Technical Service BULLETIN

POWER SLIDING DOOR DIAGNOSTIC PROCEDURE

'99 – '02 Sienna

BODY
BO010-01

ECU Bar Code Label

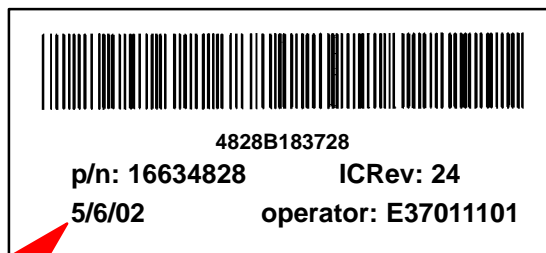
Check the date on the ECU bar code label of the new service part. If the date is **BEFORE 5/06/02**, the ECU should be replaced with an updated part.
